**City of Portland, Maine – Building or Use Permit Application** 389 Congress Street, 04101, Tel: (207) 874-8703, FAX: 874-8716

REASON FOR PERMIT: To Construct addition to shed (10x12) to (12x24)

REASON FOR PERMIT: expand shed/construct porch

PROPOSED SHED

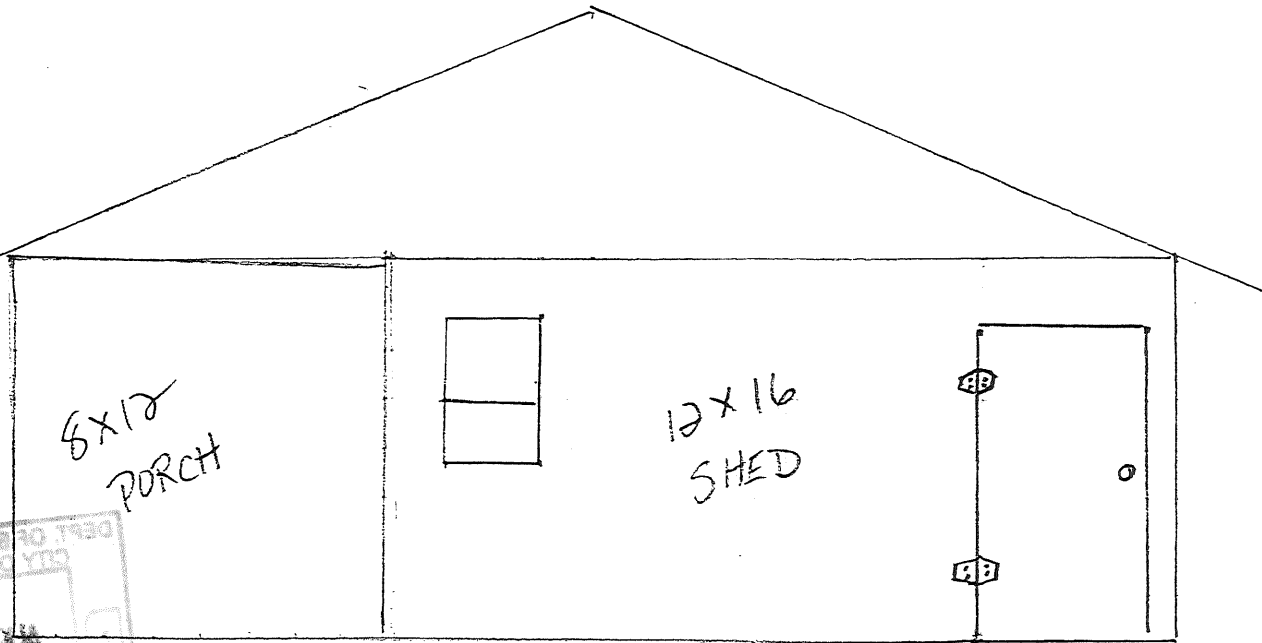
\* Proposed Use/Work - expand shed from 10x12 to 24x12 with a pack  
not turn into another  
Sewage Disposal - unit

Front Yard - 25' req - 20' existing shown - NO CHANGE

Rear Yard - 25' req - 80' shown

Side Yard - 20' req - 20' shown

Lot Coverage/ Impervious Surface - 20% MAX or 2,739.4 #

8x8	=	64
10x17		170
8x10		80
10x10		100
12x22		264
6x12		72
10x18		180
10x18		180
		<hr/>
		1090 #

1090 shed  
288  
1378

7. Separate permits shall be required for any signage.
8. Separate permits shall be required for future decks and/or garage.
9. Other requirements of condition The use of the shed is for shed uses only. This shed shall not be for a living space. No kitchen equipment shall be installed.
